SERVICE BULLETIN

Classification: AT13-012	Reference: NTB13-080	Date: August 12, 2013
-----------------------------	-------------------------	--------------------------

2010-2013 TITAN AND ARMADA; TRANSMISSION COOLER HOSE PART NUMBER CHANGE

APPLIED VEHICLES: 2010 – 2013 Titan (A60)
2010 – 2013 Armada (TA60)

Figure 1

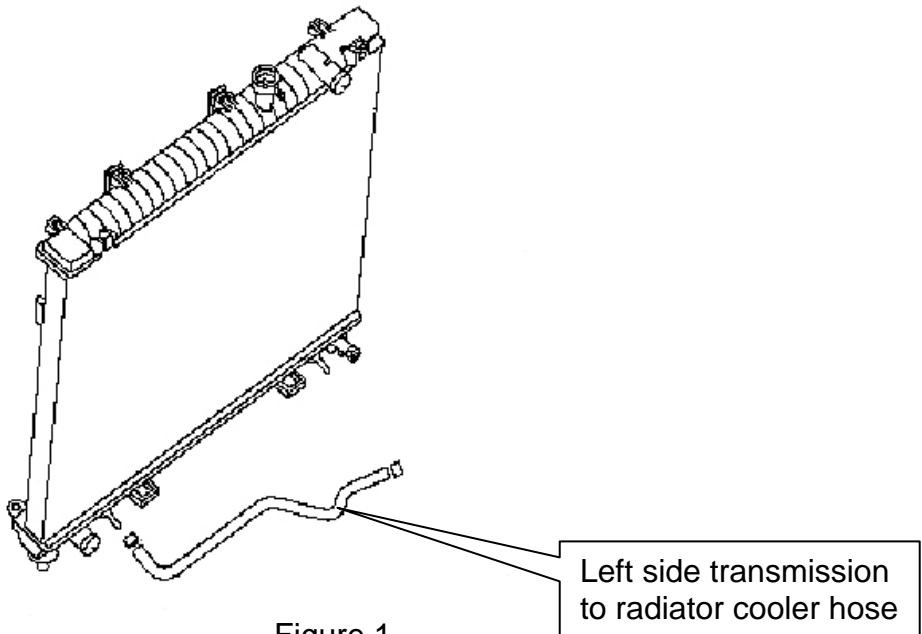
When replacing the left side transmission to radiator cooler hose shown in Figure 1 for any reason, use the superseded part listed in the Parts Information table below.

- When replacing this hose, replace both spring clamps with new ones.
- Refer to the Electronic Service manual for hose replacement information.

DESCRIPTION	PART #	QUANTITY
Transmission Cooler Hose	21632-9GF0A	1
Spring Clamp	01558-00451	2

NOTE: Do not use part number 21632-ZR00A.
